SUBJECT: RECALL R10RK BATTERY CABLE ROUTING AT REAR OF LARGE BATTERY COMPARTMENT

R10RK

Battery Cable Routing at Battery Compartment

**Models Affected: 2010 All American (D3) Rear Engine Buses Equipped
With Feature 00156-09 Heavy Duty Battery Compartment**

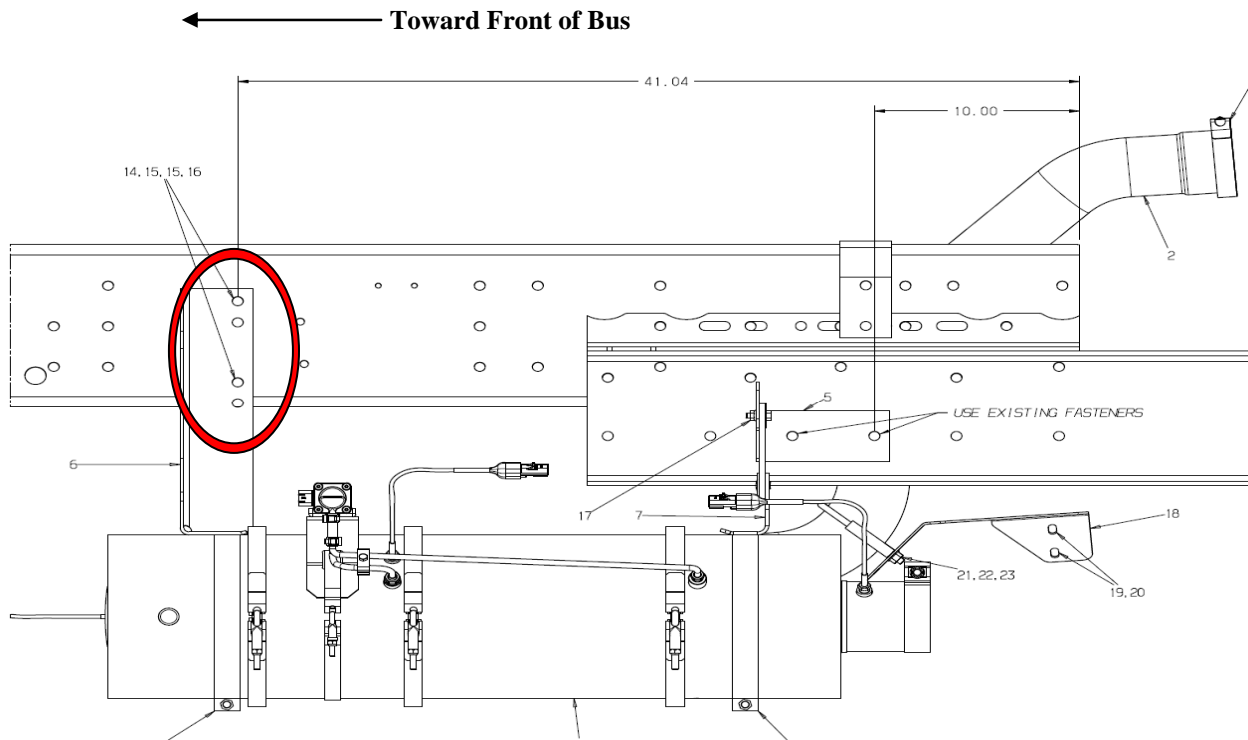
9. If exhaust muffler is contacting the battery compartment, relocate muffler exhaust bracket per diagram below for buses equipped with **Cummins ISB engines**.

Use **upper holes** in the bracket to mount to the **lower frame holes** at 41.04" from the end of frame. *Do not use the frame holes located at 40" from the end of frame.*

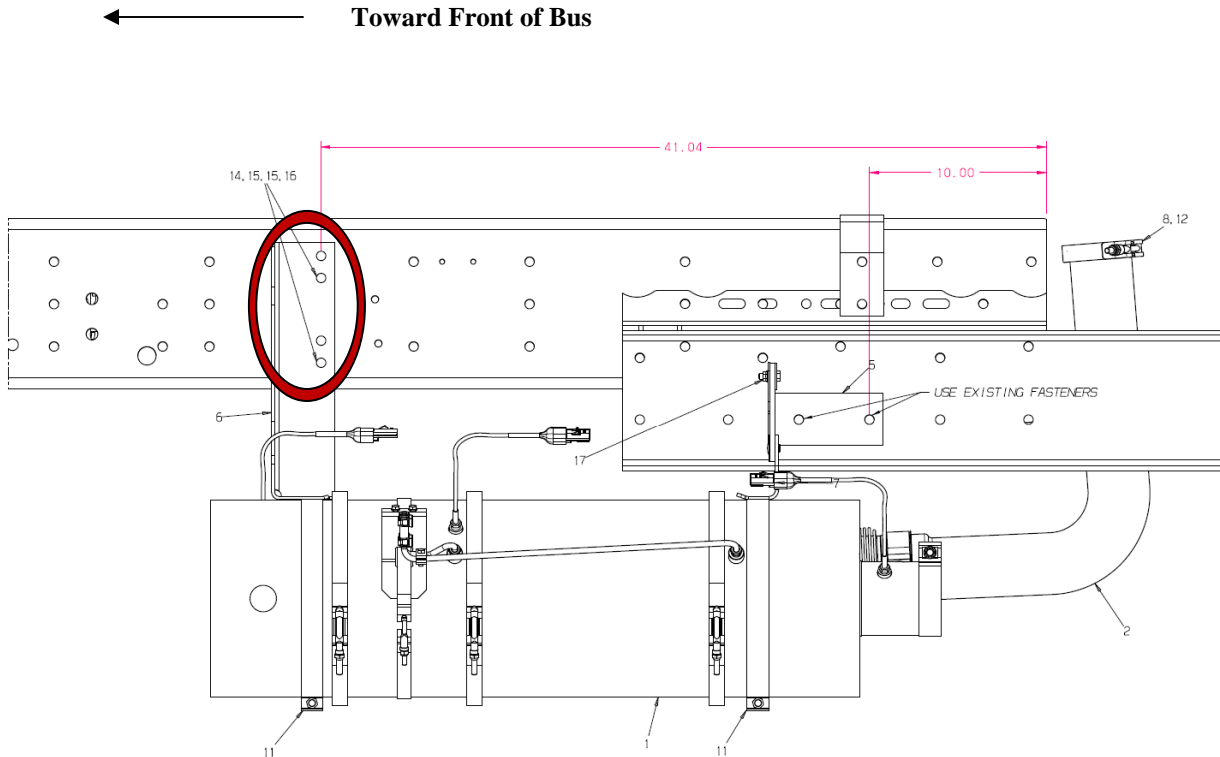
- 12. If exhaust muffler is contacting the battery compartment, relocate muffler exhaust bracket per diagram below for buses equipped with **Cummins ISC engines**.

Use **lower holes** in the bracket to mount to the **lower frame holes** at 41.04" from the end of frame. *Do not use the frame holes located at 40" from the end of frame.*
